Subject: SUIT AND HELMET SESSION WITH [Redacted] OF DAVID CLARK, 23 MARCH 1966

Subject: RECORD OF SUIT AND HELMET SESSION WITH  
[Redacted] OF DAVID CLARK, MARCH 23, 1966

Suit Outer Surface Decision:

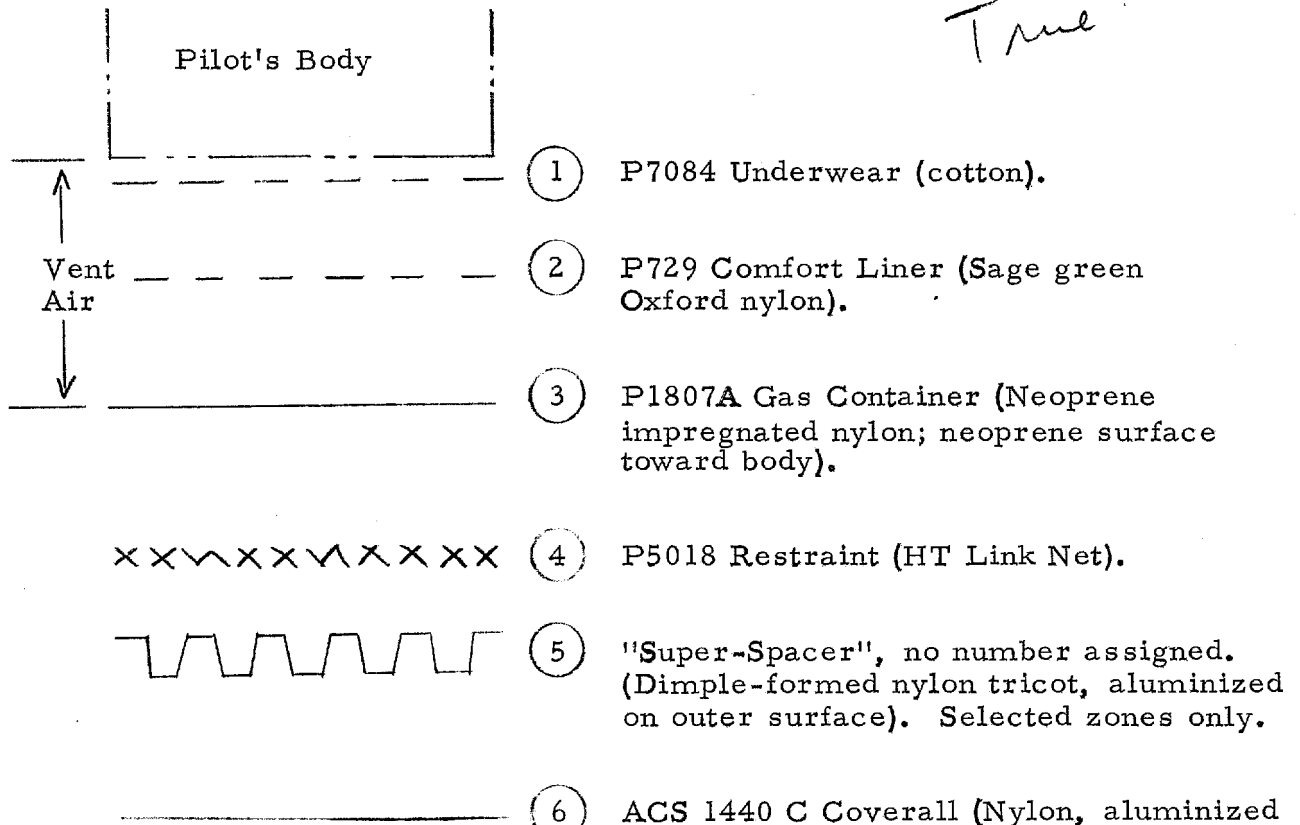
It is becoming obvious that the suit must reflect both solar and I. R. wavelengths in the cockpit environment vs. the solar only problem for Gemini. This means that the new aluminized suit will be better as shown in our SP-795 report which you have. The final decision as to the use of aluminized or white HT will be the result of flight usage and comparing well worn and washed garments.

SUIT OUTER SURFACE DECISION:

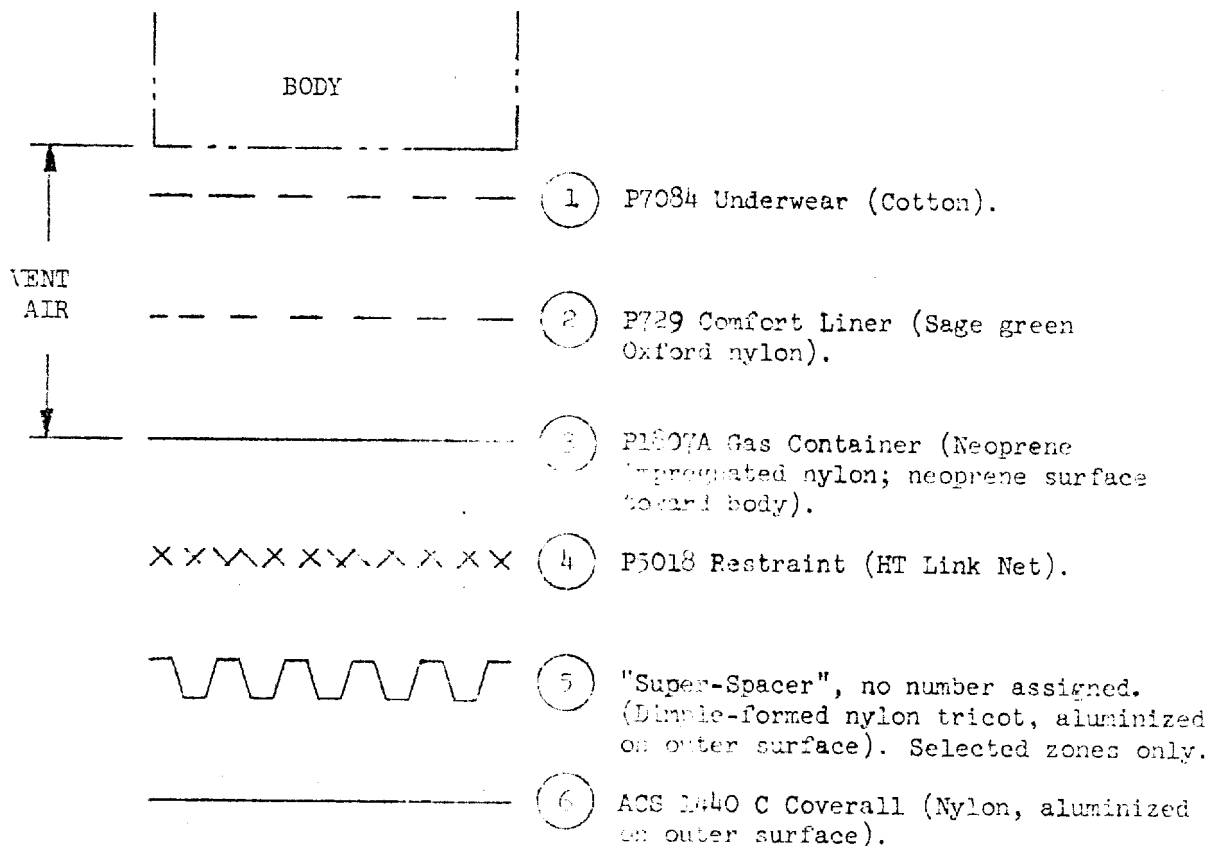
It was agreed between [redacted] and myself that the outer surface of the suit should remain aluminized, and that no further consideration should be given to changing to a white surface. This is consistent with the "real" cockpit environment, wherein the suit surface must efficiently reflect not just solar but both solar and I.R. wavelengths, as pointed out in my Suit Problem Report SP 795.
